The Commission has issued the enclosed Amendments Nos. 39, 37 and 13 to Facility Licenses Nos. DPR-33, DPR-52 and DPR-68 for the Browns Ferry Nuclear Plant, Units Nos. 1, 2 and 3. These amendments consist of changes to the Technical Specifications in response to your request of May 17, 1978 (BFNP TS 109) regarding implant electrical system modifications as described in your letter of May 2, 1978. With your concurrence, we have modified the Technical Specifications to more specifically describe the equipment affected by the modifications.

BROWNS FERRY NUCLEAR PLANT, UNIT NO. 1

AMENDMENT TO FACILITY OPERATING LICENSE

BROWNS FERRY NUCLEAR PLANT, UNITS NOS. 1, 2 AND 3

Figure 1  
Modified Configuration

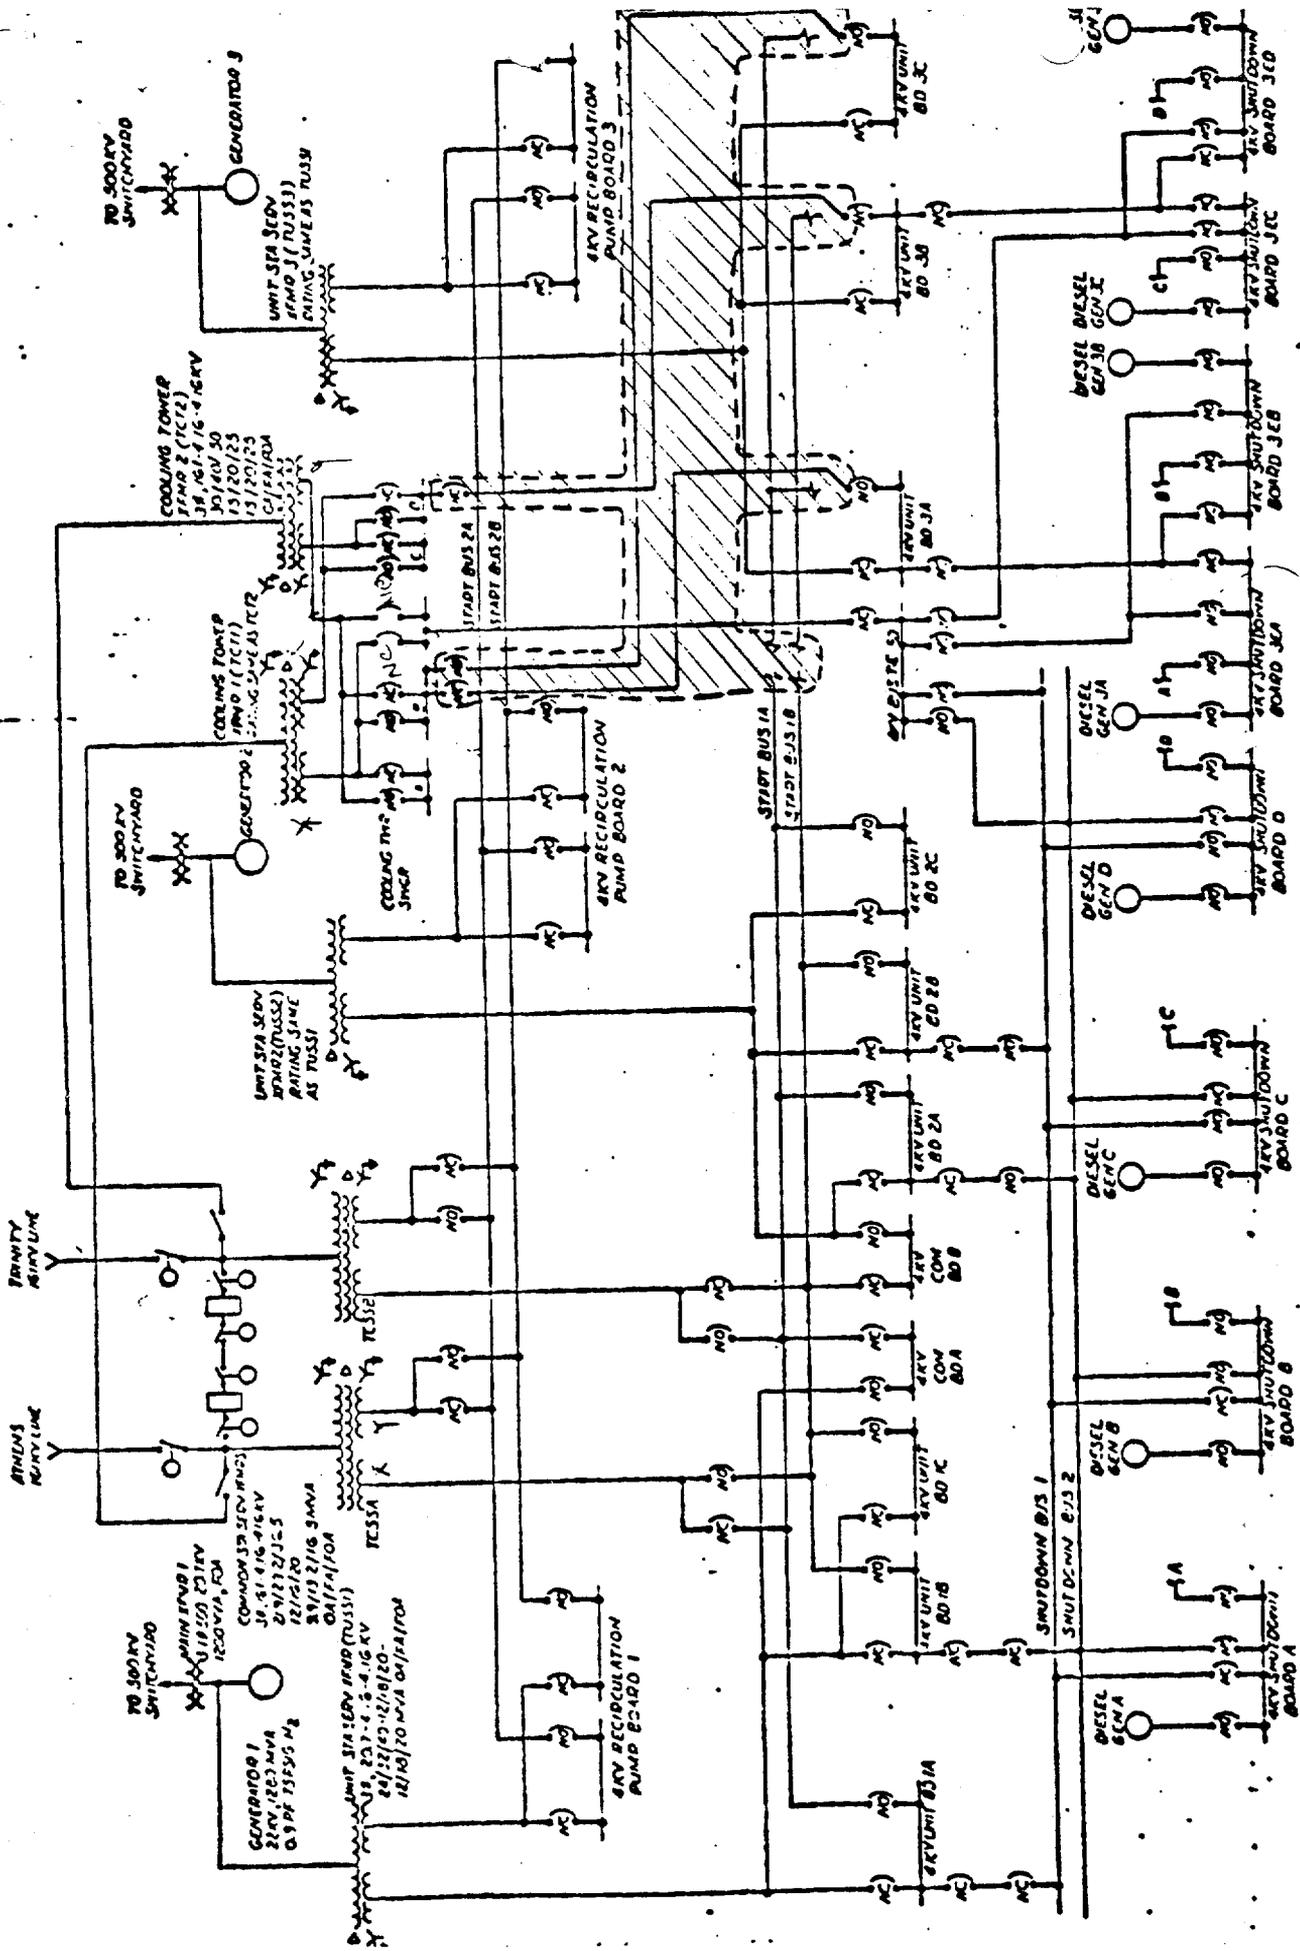
The system modifications to correct the inplant system undervoltage consist of: (a) installation of capacitor banks at the Browns Ferry terminal ends of the two 161 kV transmission lines to improve the power factor and (b) rearranging the 4160 volt loads of Unit 3 to reduce the voltage drop due to high impedance in common station service transformers.

Unit 3 boards 3A, 3B, and 3C will be cut off the start bus 1A and 1B and will be supplied from cooling tower transformers 1 and 2 as shown in the cross-hatched portion of Figure 1. The offsite supplies for shutdown boards 3EA and 3EB, and for shutdown boards 3EC and 3ED are fed through board 3A and 3B, respectively. The 4kV bus tie board can be supplied power by either of the cooling tower transformers and remains unchanged from the original design.

The feeder cables for these offsite power supplies are routed in separate cable trenches to the cooling tower transformers. The system modifications also improve the power factor on the offsite power source by installing the capacitor banks on 161 kV line, and reduce the voltage drop on the inplant system by rearranging the 4160 volt loads to common station service transformers and cooling tower transformers. The modified configuration would result in a voltage of 3950 volts on 4160-volt inplant system for the postulated events.

The staff has reviewed the licensee's proposed modifications to the plant system - the installation of two capacitor banks and the rearrangement of the Unit No. 3 4160 volt loads to improve the inplant system voltage. The staff also reviewed the associated changes to the Technical Specifications resulting from these modifications. Based on the evaluation of the information provided by the licensee, the staff concludes that the proposed system modifications are an acceptable method of assuring that the inplant system voltages satisfy the requirements of General Design Criterion 17 with regard to system capacity and operability. With the changes we have proposed and which the licensee has accepted, the staff finds the changes to the Technical Specifications to be acceptable.
